**DIVISION OF RATEPAYER ADVOCATES
CALIFORNIA PUBLIC UTILITIES COMMISSION**

A.06-08-010

REPORT ON THE SUNRISE POWERLINK

**Phase 1 Direct Testimony
Volume 3 of 5**

FIGURE 2-1
 SDG&E Sunrise Powerlink 2015 Gas Price Forecast in Context
 (Nominal \$/MMBtu)

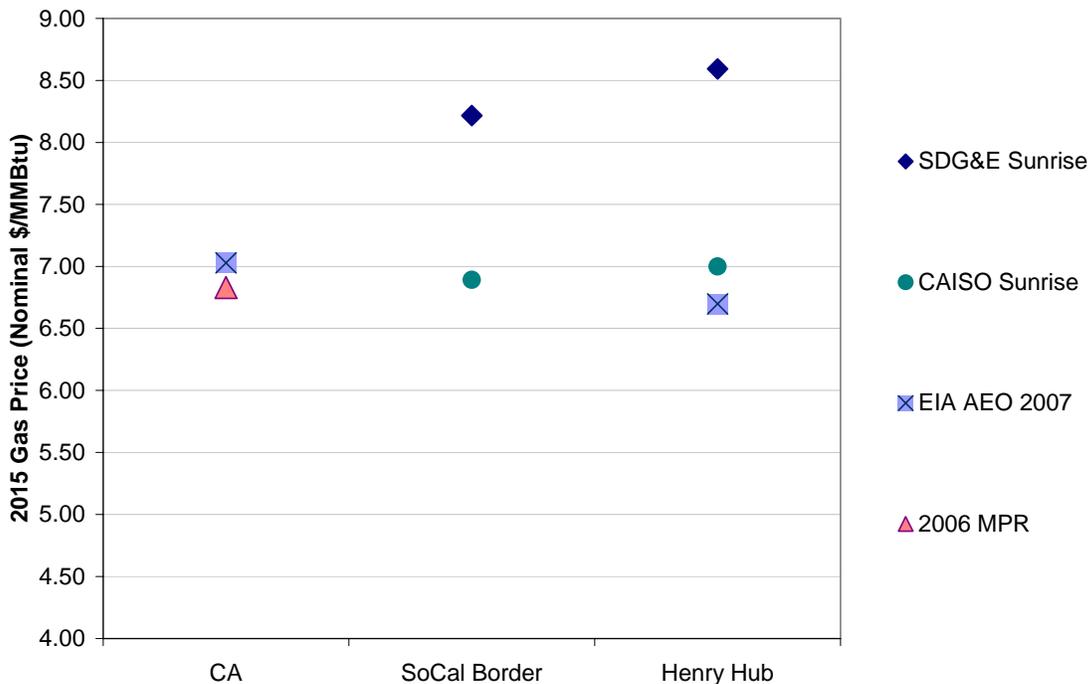
24 For modeling purposes, SDG&E made use of the \$7.00/MMBtu (real 2005\$) gas price
25 forecast that came with its WECC economic (SSG-WI) database. By 2015, after
26 accounting for inflation, the forecast is almost \$9.00/MMBtu. The forecast is therefore

1 28 percent (or \$1.89/MMBtu (2015\$)) higher than the EIA’s Annual Energy Outlook
 2 2007 forecast⁵ and 27 percent (\$1.85/MMBtu) higher than the gas prices used to compute
 3 the Commission’s 2006 Market Price Referent.⁶ Based on this simple survey, SDG&E’s
 4 gas prices do not appear reasonable for use in base case modeling, but are better suited
 5 instead for a “high” gas price sensitivity. Another useful point of reference is provided in
 6 Confidential Appendix B to this Volume 3. Figure 2-1 below illustrates the issue.
